Description : CHAGE ORDER NO 2 -PROJECT ST BERNARD MAIN YARD SITE WORK

CHANGE ORDER

OWNER St. Bernard Parish Government
 CONTRACTOR Phoenix Constructors, LLC
 Contract: _____
 Project: St. Bernard Main Yard Site Work (Improved Project)
 OWNER's Contract No. FEMA PW 19795 ENGINEER's Contract No. 89239.1
 ENGINEER Shread-Kuyrkendall & Associates, Inc.

**Add Scope of Work Item for "Safety Ends Required at Drainage Outfalls"
 Adjust Contract Time, as described below**

ST. BERNARD PARISH
MAIN YARD SITE WORK
DRAINAGE - SITE PLAN

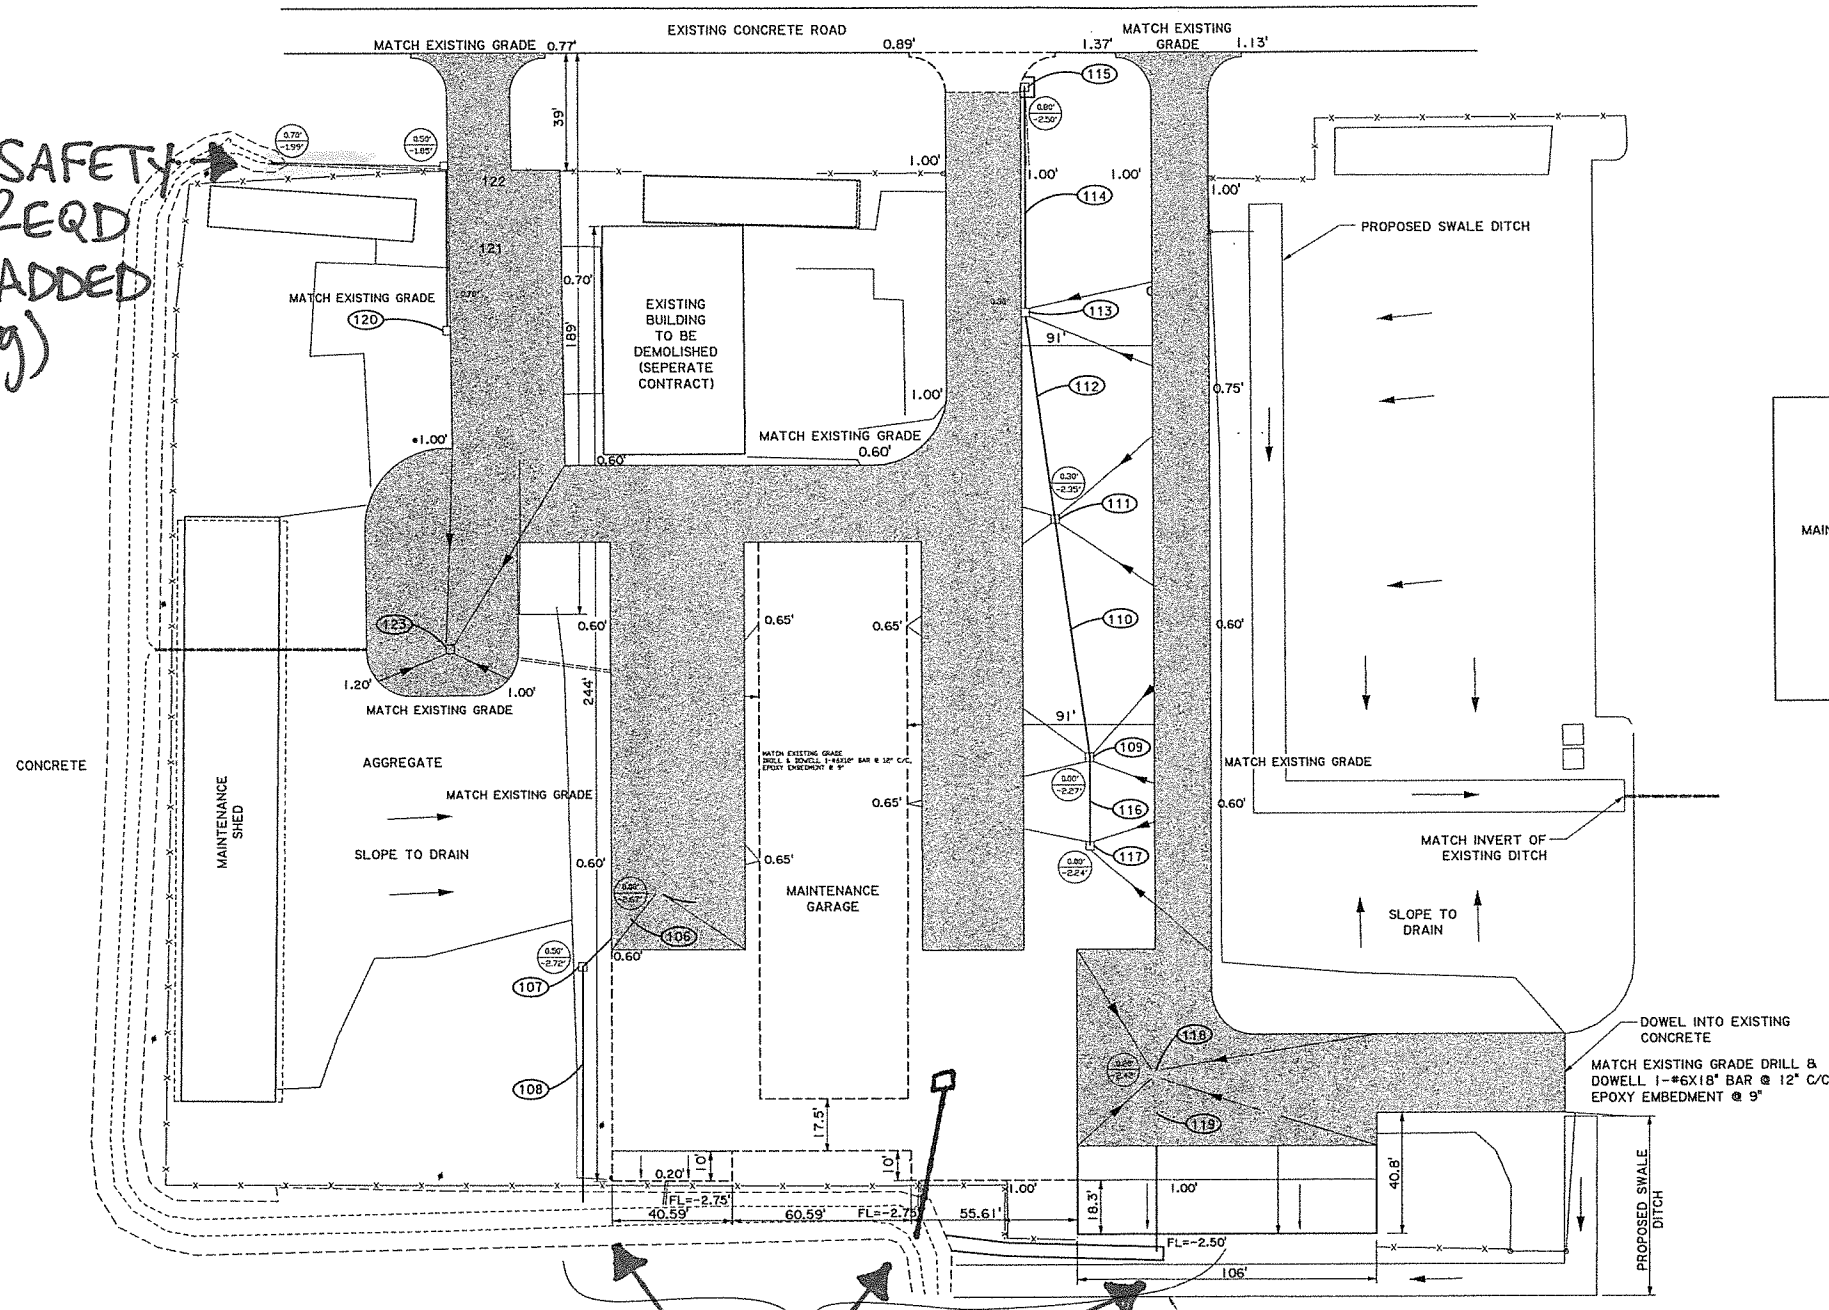
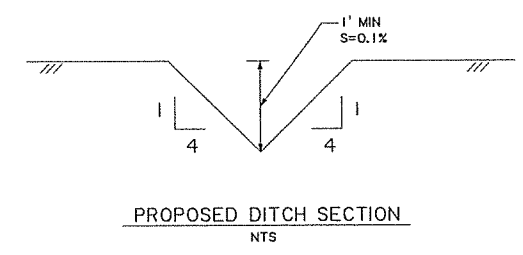
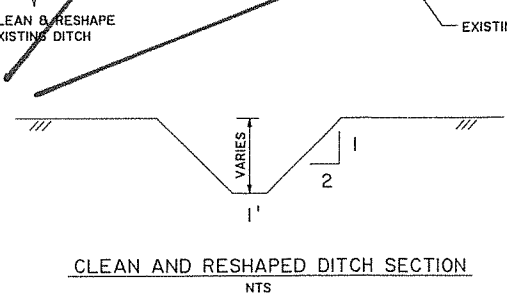
ADDTL SAFETY
END REQD
(NO \$ ADDED
per mtg)

THREE (3) SAFETY
ENDS PER \$ IN
C.O. # 2

SAFETY END DETAIL

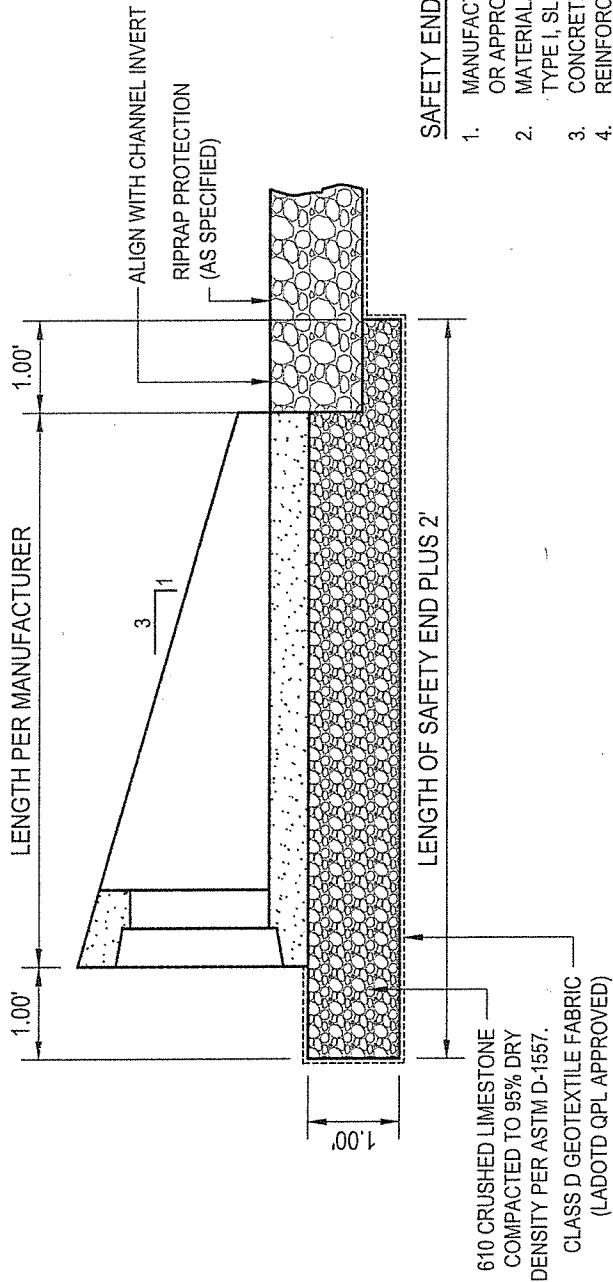
1. MANUFACTURER: HANSON (FORTERRA) PRODUCTS, OR APPROVED EQUAL
2. MATERIAL/CONFIGURATION: PRECAST CONCRETE, TYPE I, SLOPE = 3:1; SEE PLAN FOR PIPE SIZE & TYPE
3. CONCRETE: 4,000 PSI IN 28 DAYS
4. REINFORCING STEEL: PER ASTM A-615, GRADE 60
5. REINFORCING TO HAVE 2" MINIMUM COVER
6. ALL EXPOSED CORNERS TO BE CHAMFERED 3/4"
7. PIPE TO SAFETY END CONNECTION SHALL BE SEALED WITH FLEXIBLE GASKET MATERIAL
